Rezoning Transportation Analysis
Petition Number: Insert Zoning Petition #2021-209
General Location Identifier: 20109103

Revision Log:	Date	Description
	01-24-2022	First Review (KP)

General Review Information

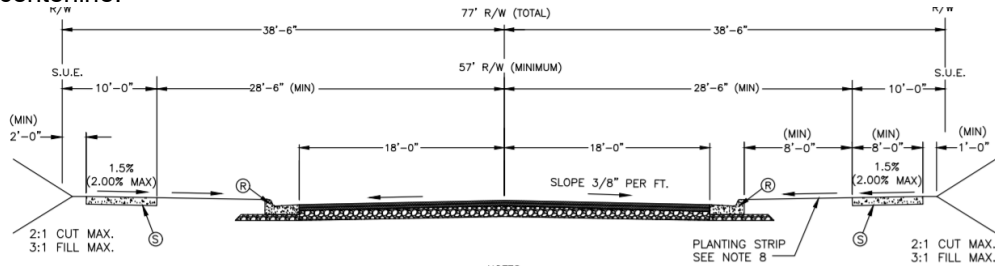
1. **Curb line:** The proposed zoning district has a setback measured from back of the existing or proposed future curb line.
 - a. **Steele Creek Road:** Curb and gutter will be constructed in accordance with the typical section established in the U-5766 STIP Project, as generally depicted on the site plan.

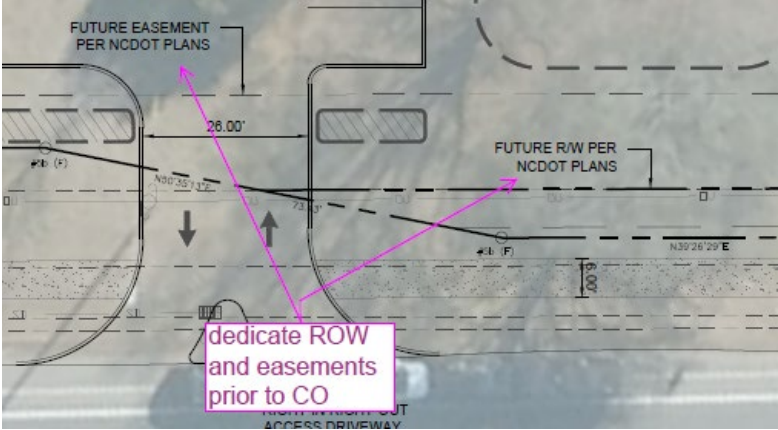
- b. **Rigsby Road:** Curb and gutter will be constructed in accordance with CLDSM U-05A, Local Commercial Wide cross section with the back-of-curb located 20.5-feet from the existing centerline.

Label and dimension the back of curb and gutter from the existing centerline of each road.

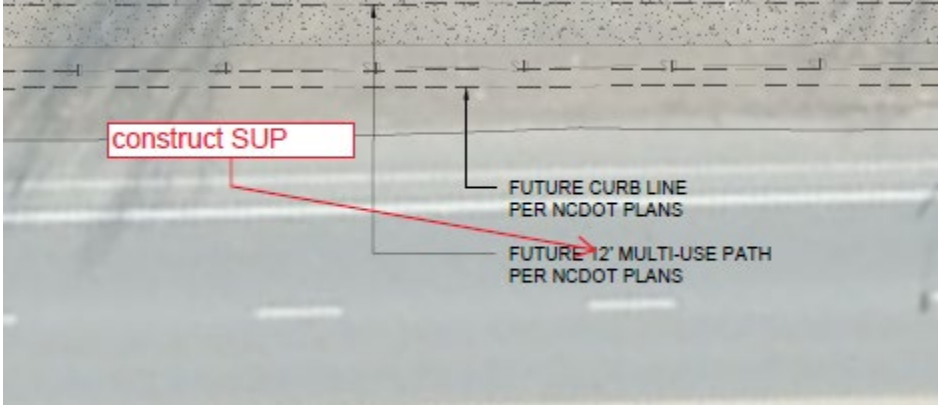
- a. **Steele Creek Road:** Revise site plan and conditional note(s) to commit to dedicate the right-of-way and easements, in accordance with the typical section established in the U-5766 STIP Project, as generally depicted as on the site plan.

- b. **Rigsby Road:** Revise the site plan and conditional notes to dedicate 38.5-feet of right-of-way, in accordance with CLDSM U-05A Local Commercial Wide cross section, from the existing road centerline.

The site plan shall label and dimension the right-of-way from the road centerline.

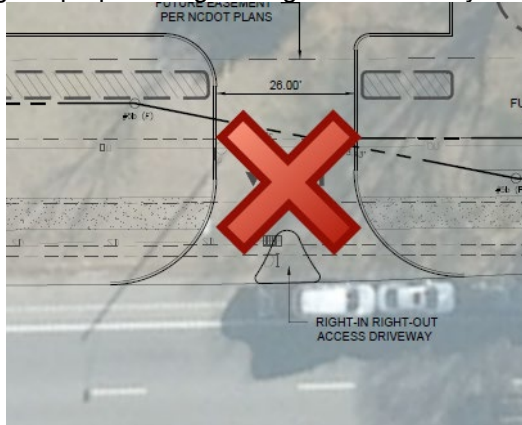
- 4. Revise site plan and conditional note(s) to commit to construct an 8-foot planting strip and 8-foot sidewalk along the site's frontage of Rigsby Road, in accordance with CLDSM U-05A, Local Commercial Wide cross section. The site plan shall label and dimension both items from the back of curb and gutter and road centerline.
- 5. Revise site plan and conditional note(s) to commit to construct the 12-foot shared-use path along the site's frontage of Steele Creek Road, in accordance with the typical section established in the U-5766 STIP Project, as generally depicted on the site plan.

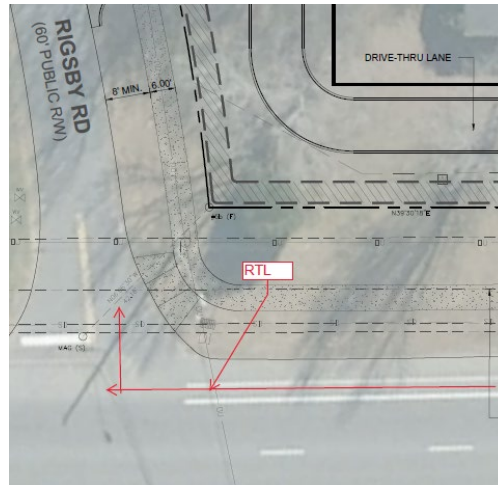
6. Revise site plan by removing the proposed right-in right-out driveway on Steele Creek Road.
